# EXHIBIT A

| NO. | DATE      | DESCRIPTION                                                                                   |
|-----|-----------|-----------------------------------------------------------------------------------------------|
| 1   | 6/13/2016 | REVISED BY DAVID EVANS AND ASSOCIATES PER RAINIER VIEW WATER COMPANY COMMENTS DATED 6/13/2016 |

**OLYMPIC TOWNE CENTER**

**FINAL**  
**WATER MAIN SITE PLAN/INDEX SHEET**

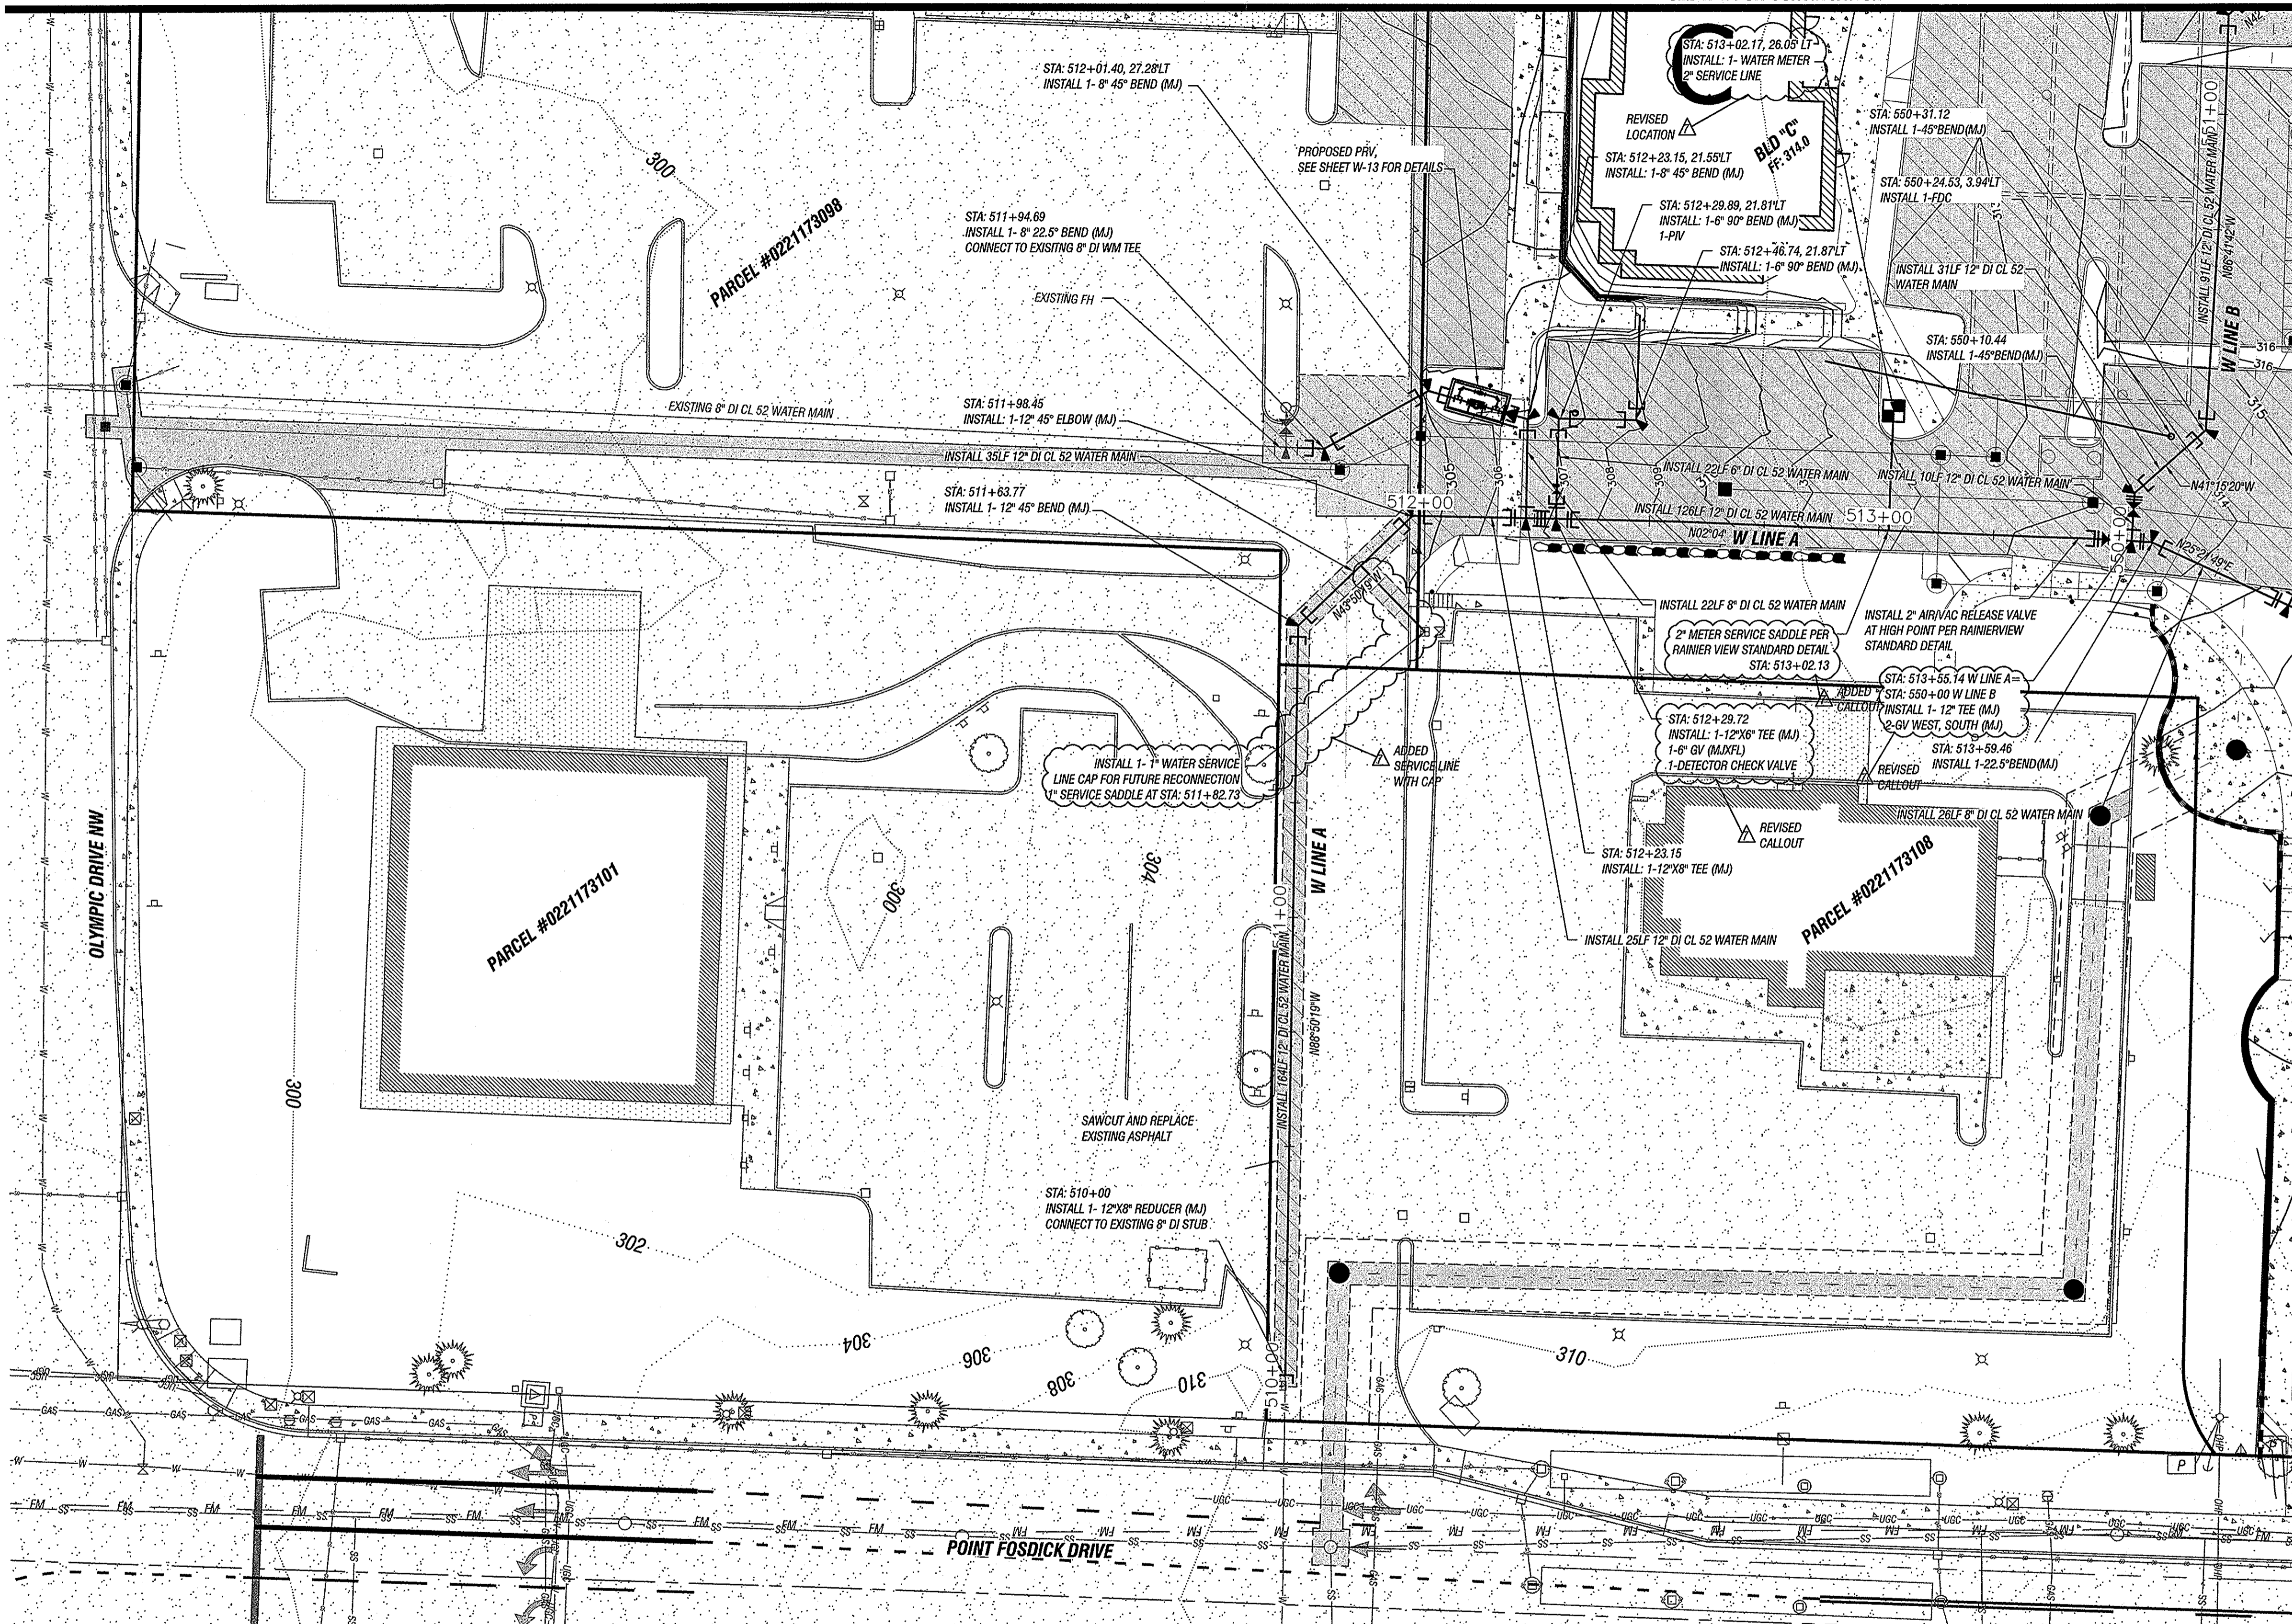
ABANDON EXISTING WATERMAIN IN PLACE EXCEPT UNDER PROPOSED STRUCTURES. REMOVE EXISTING WATERLINE FROM UNDER TANK AND PUMPSTATION

## PRESSURE REDUCING VALVE (RAINIER VIEW)

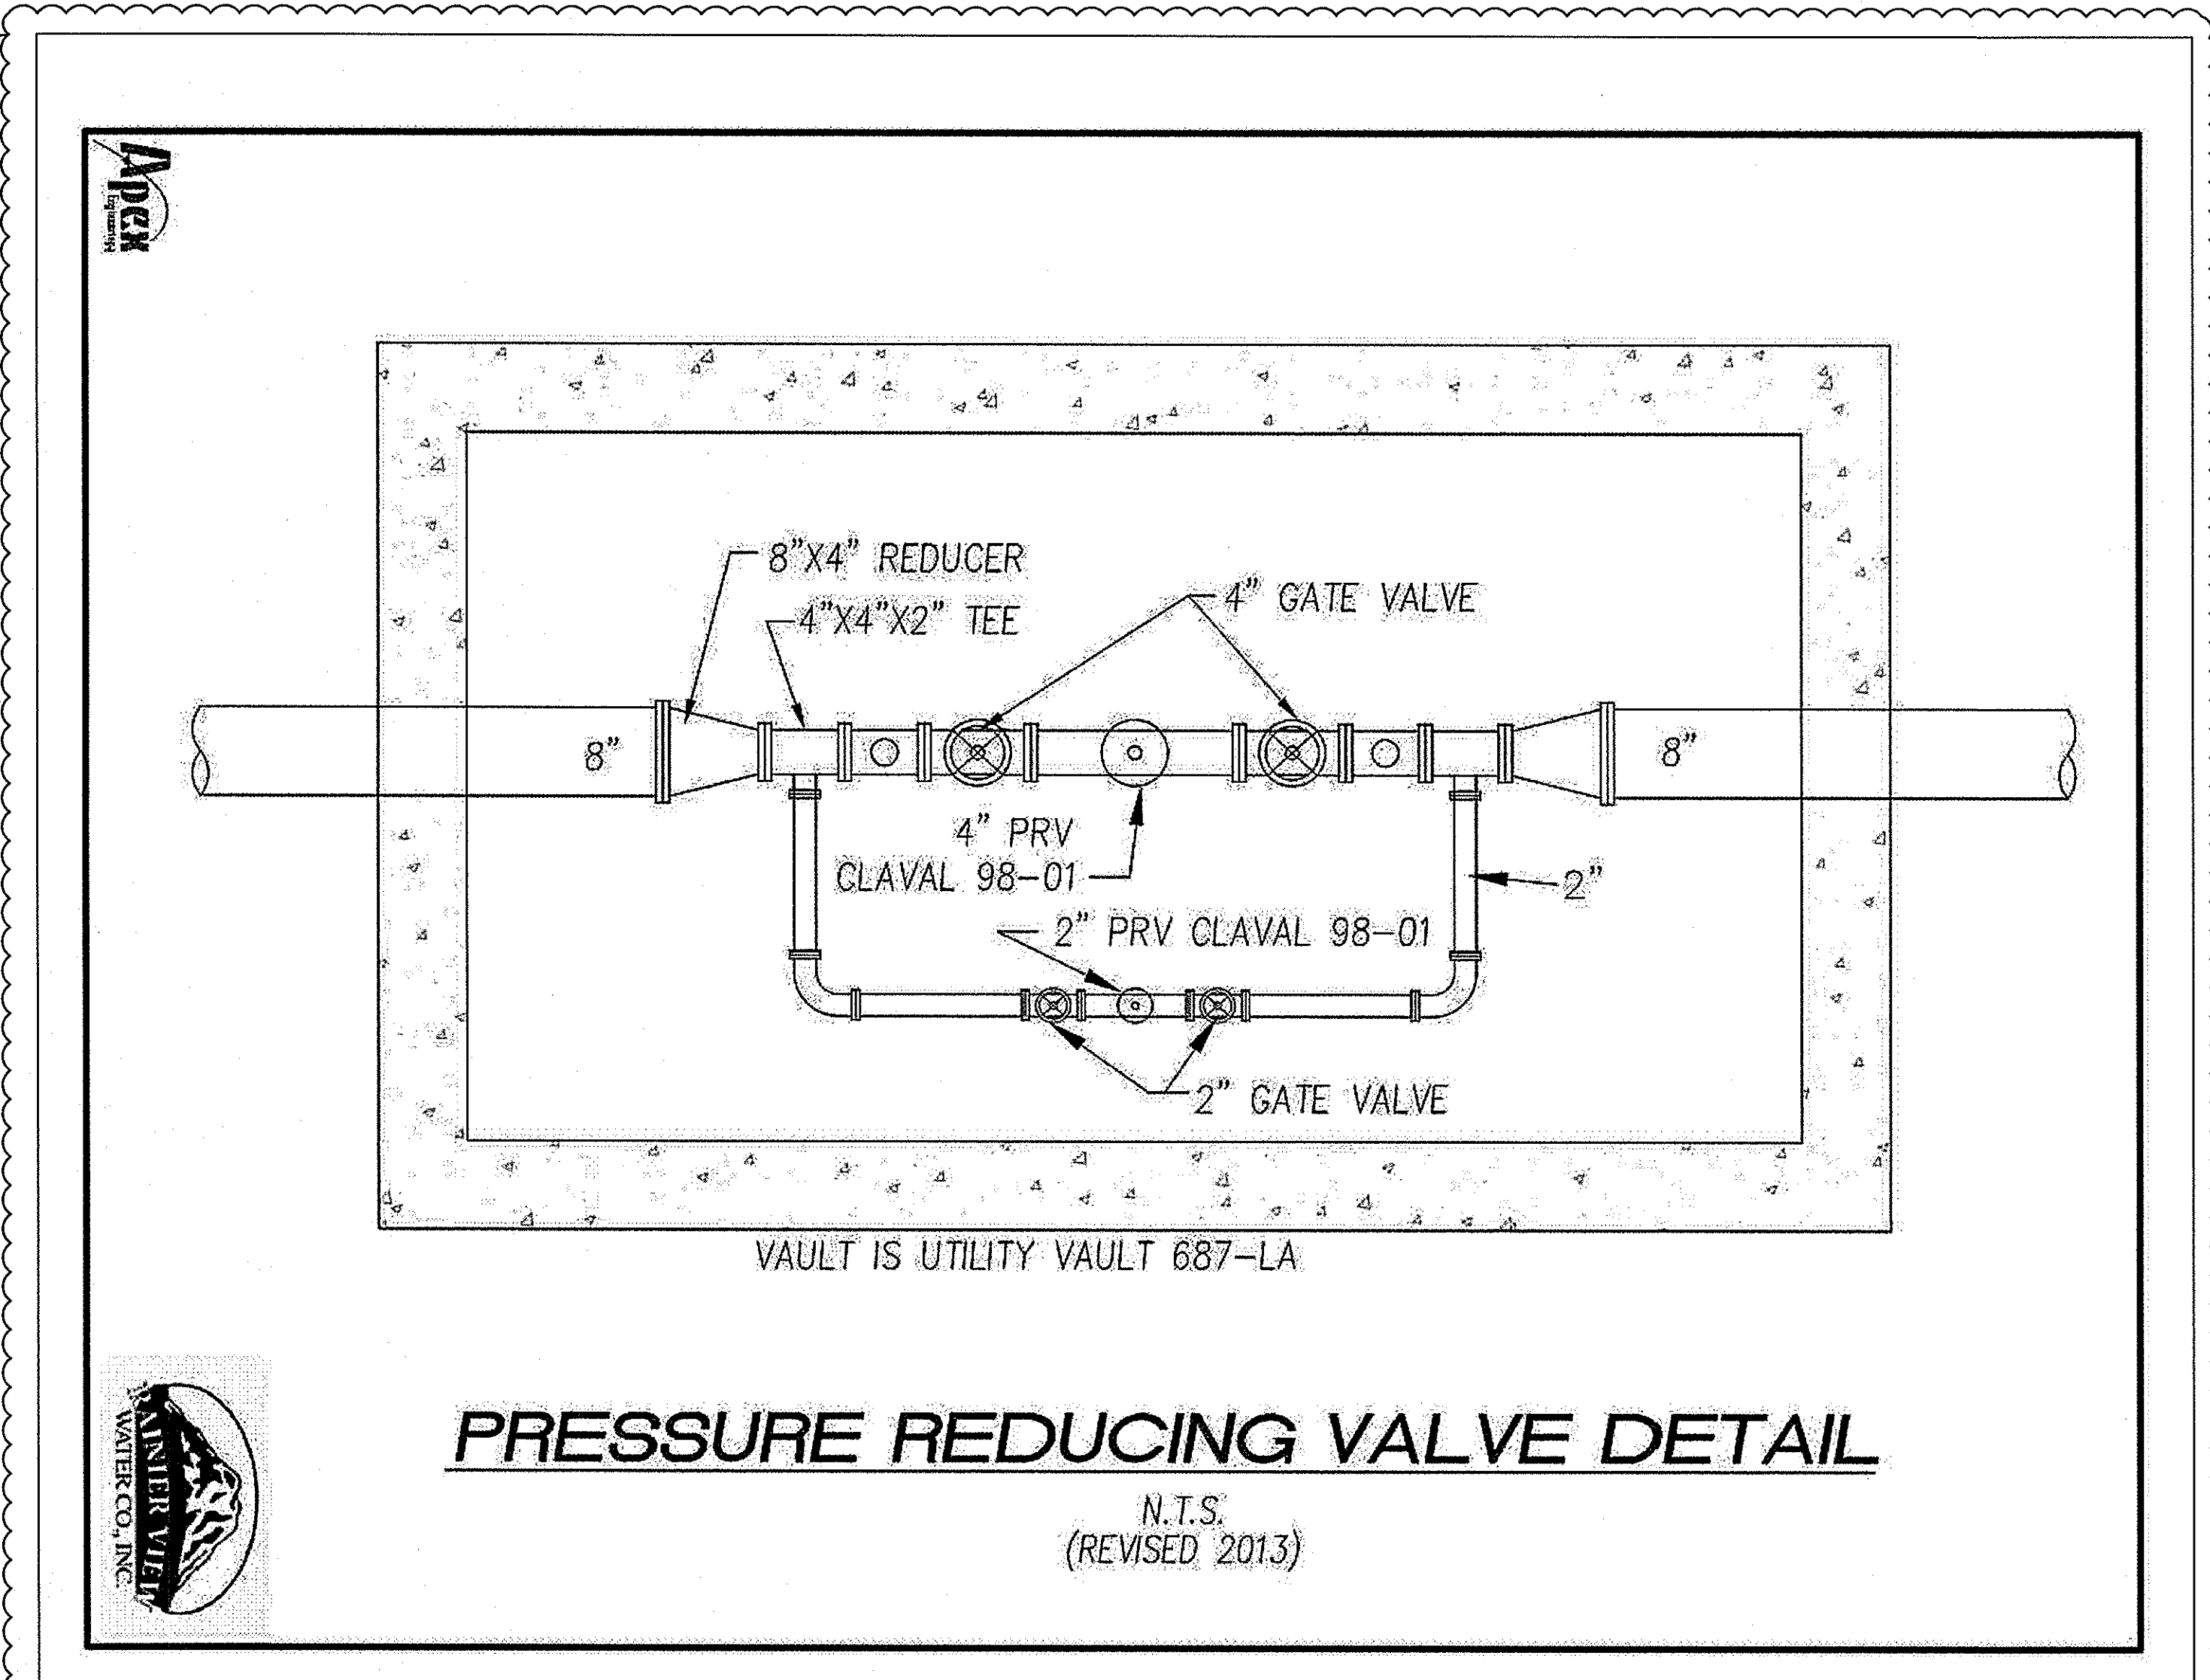
REPLACED PRV DETAIL WITH  
 RAINIER VIEW WATER COMPANY  
 STANDARD DETAIL

| REVISIONS                                                                                   | DATE   |
|---------------------------------------------------------------------------------------------|--------|
| REPLACED PRV DETAIL WITH RAINIER VIEW WATER COMPANY STANDARD DETAIL                         | 6/2016 |
